Response to Referee#1

Note: Comment of Referee 1 is in Green and Referee 2 is in blue colour

Line 92: There are a total of 12 Indian Himalayan states and 1 Union territory as shown in Figure 1, which has 109 administrative districts (Kala, 2014).

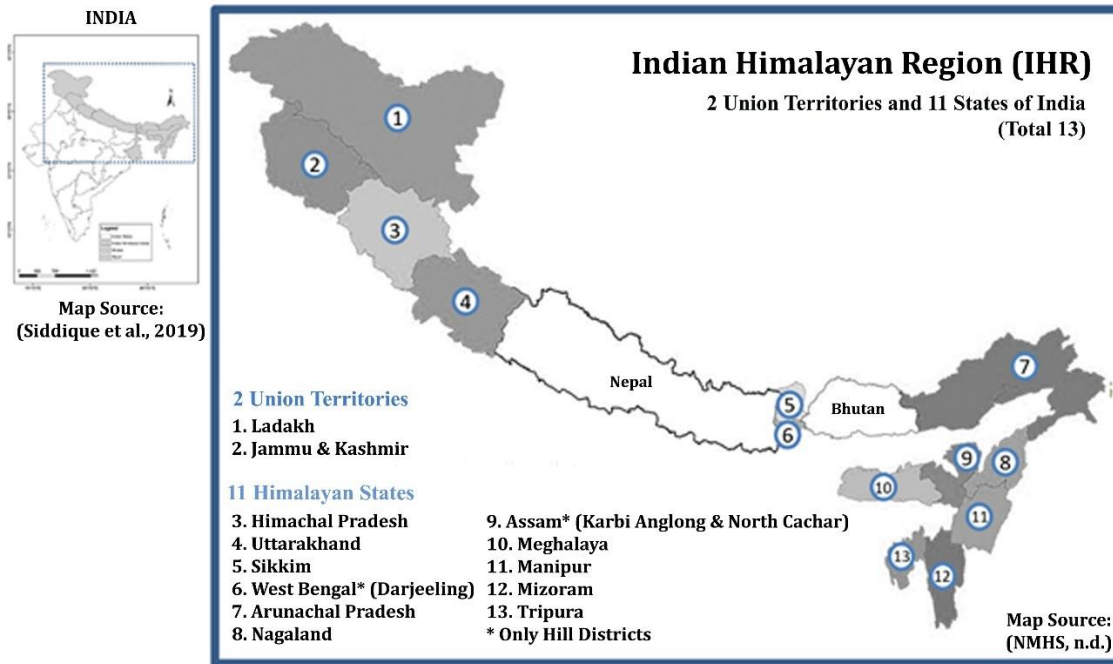
Comment (R1)-4: In line 92, There are two Union Territories not one accordingly modification are needed in text.

Response: We appreciate the reviewer's insightful observation and taking this comment into consideration, we have updated it in text as well as in figure 1.
